PROJECT NAME:	SUDBURY-BRANDON
PROJECT NUMBER:	STP 0158(3)

FILE NAME: dl0c204_typ.dgn	PLOT DATE: 13-FEB-2013
PROJECT LEADER: K. UPMAL	DRAWN BY: B. MCADAMS
DESIGNED BY: B. MCADAMS	CHECKED BY: A. KEMPTON
TYPICAL SECTION SHEET 1	SHEET 3 OF 137

TYPICAL SECTIONS

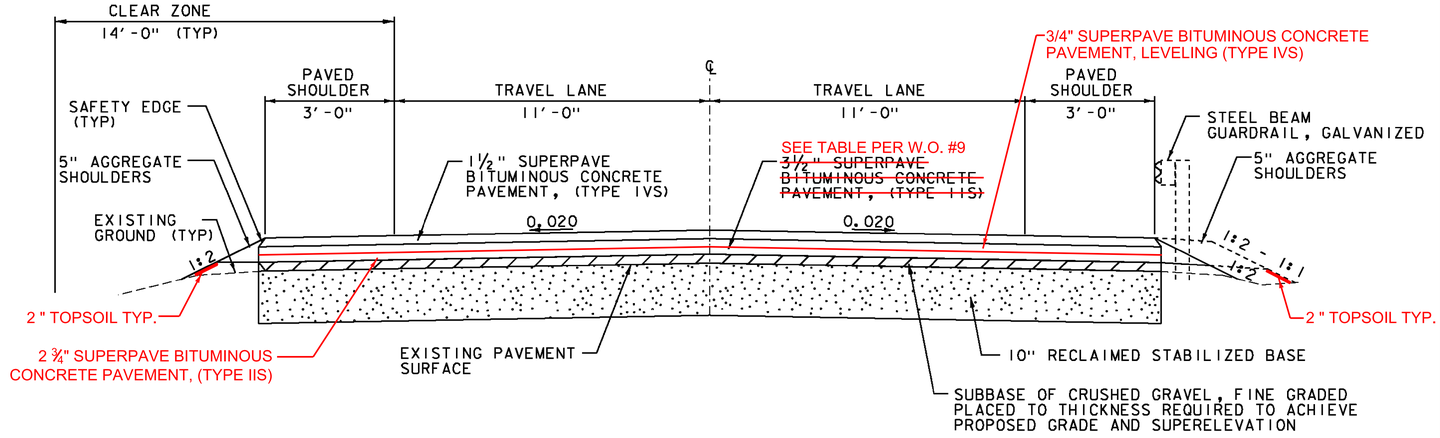
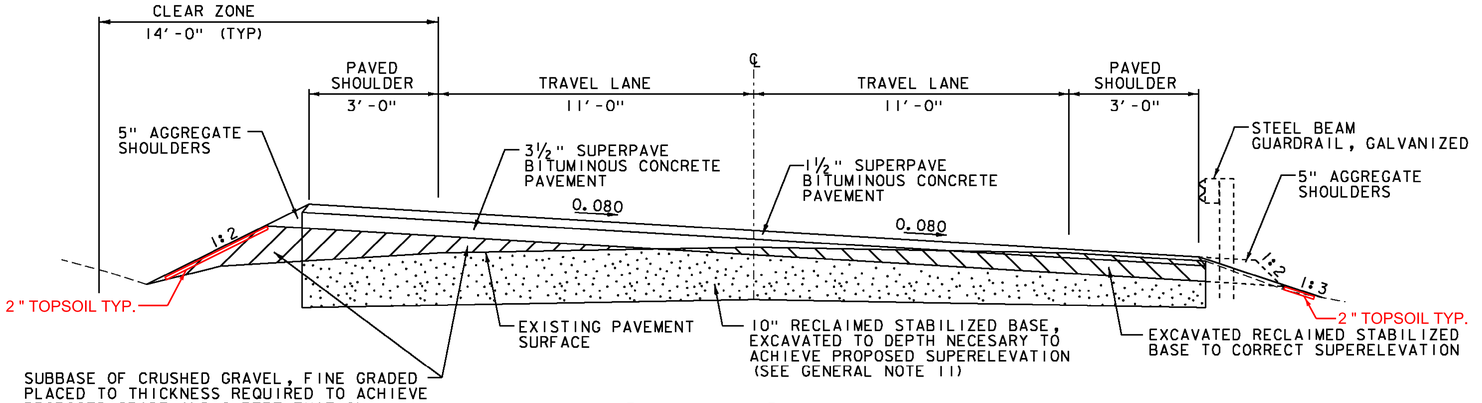
PER WRITTEN ORDER #9 CHANGE OF PAVEMENT THICKNESS:
- 2¾" TYPE II S BASE
- ¾" TYPE IV S LEVELING
- 1½" TYPE IV S WEARING
